BALLARD ESTATES SUBDIVISION

APPLICATION NUMBER 10 DATE March 19, 2009

REQUEST Subdivision

DETAIL SITE PLAN

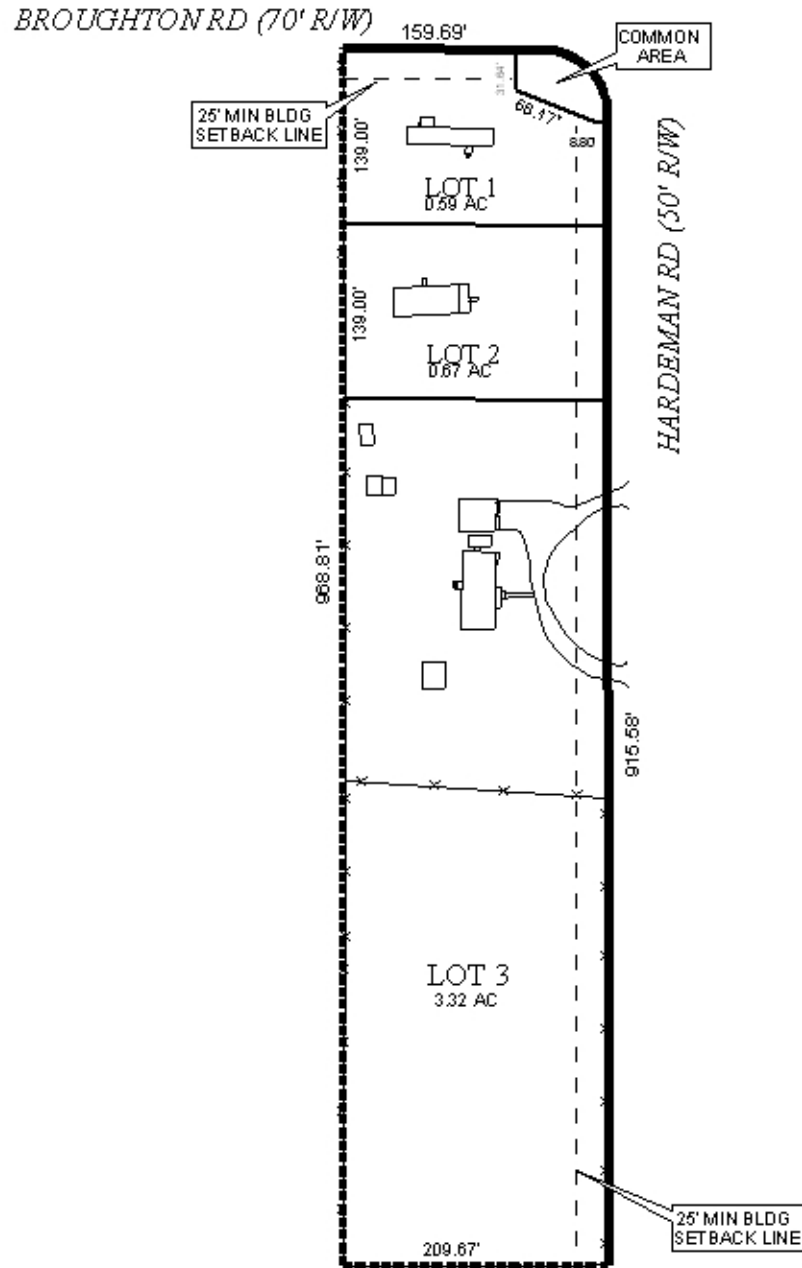
The plat illustrates the proposed 3 lot, 4.6 ± acres subdivision located at the Southwest corner of Hardeman Road and Southridge Drive, an extension of Broughton Road, in the Planning Jurisdiction. The applicant states that the subdivision is served by public water and individual septic systems.

Each lot is labeled with its size in acres on the plat. This should be revised on the final plat to label each lot with its size in both square feet and acres, or a table should be provided on the plat furnishing the same information.

A common are is indicated at the intersection of Southridge Drive and Hardeman Road. A note should be required on the final plat stating that the maintenance of the common area is the responsibility of the property owners and not Mobile County.

- 1) illustration of the 25’ minimum building setback line from the current right-of-way along Southridge Drive;
- 2) illustration of a 50’ minimum building setback line along Hardeman Road, as measured from the current right-of-way line, so as to allow a 25’ building setback as measured from the future right-of-way of the Major Street Plan;
- 3) placement of a note on the final plat stating that Lot 1 is limited to one curb cut to Southridge Drive and one curb cut to Hardeman Road, Lot 2 is limited to one curb cut to Hardeman Road, and Lot 3 is limited to two curb cuts to Hardeman Road, with the size, location and design of all curb cuts to be approved by County Engineering and conform to AASHTO standards;
- 4) revision of the plat to label each lot with its size in both square feet and acres, or the provision of on the plat furnishing the same information;

- 5) placement of a note on the final plat stating that the maintenance of the common area is the responsibility of the property owners and not Mobile County;
